Access Compliance Report

Public Rights-of-Way

(Curb Ramps)

Intersection ID: N/A	Main Street: TWITTER_LN	Cross Street: ROCKY_RIVER_RD	Location: NW
ADA ID: 454CA4B29F14	Ramp Type: Para	Initial Pass/Fail: Fail	Overall Compliance: No
Codes/Mitigation Info/Possible Solution		Field Measurements/Component Compliance	
Severity Score: 12.5

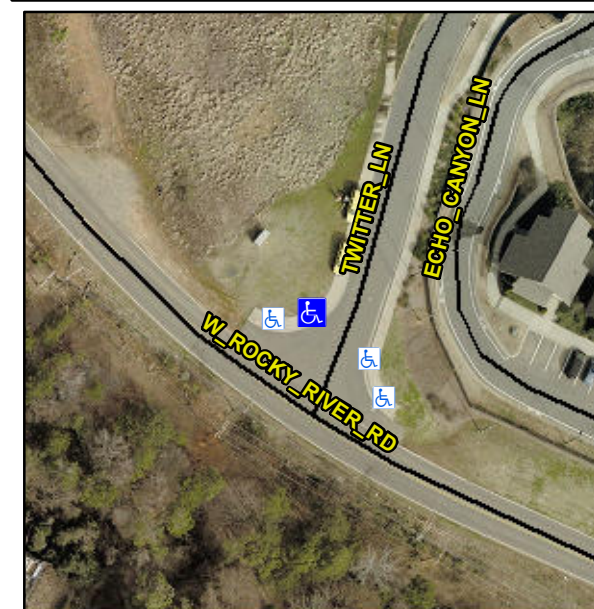
RT RP < 5%

R304.3.2

Compliance	Description	Data	Compliance	Description	Data
N/A	Ramp Length LT (in)	57.0	N/A	Ramp Length RT (in)	56.0
Yes	Ramp Width LT (in)	60.0	Yes	Ramp Width RT (in)	60.0
No	Ramp Slope LT (%)	11.2	Yes	Ramp Slope RT (%)	4.3
Yes	Ramp XSlope LT (%)	0.4	Yes	Ramp XSlope RT (%)	1.8
N/A	Landing Length (in)	N/A	N/A	DWS Provided?	N/A
N/A	Landing Width (in)	N/A	N/A	DWS Contrast?	N/A
N/A	Landing Slope (%)	N/A	N/A	DWS Length (in)	N/A
N/A	Landing X Slope (%)	N/A	N/A	DWS Full Width?	N/A
N/A	Landing Curb? (Y/N)	N/A	N/A	DWS Offset (in)	N/A
N/A	Shared Landing?	N/A			
N/A	Gutter Ponding?	N/A	N/A	Gutter Slope (%)	N/A
N/A	Gutter Lip Ht (in)	N/A	N/A	Gutter X Slope (%)	N/A
N/A	Painted X Walk1?	No	N/A	Painted X Walk2?	N/A
	X Walk 1 Direction	To E		X Walk 2 Direction	N/A
N/A	X Walk 1 Width (in)	N/A	N/A	X Walk 2 Width (in)	N/A
	X Walk 1 Slope (%)	1.6		X Walk 2 Slope (%)	N/A
	X Walk 1 X Slope (%)	1.5		X Walk 2 X Slope (%)	N/A
N/A	Ramp inside XWalk1?	N/A	N/A	Ramp inside XWalk2?	N/A

Remove & Replace Entire Ramp.
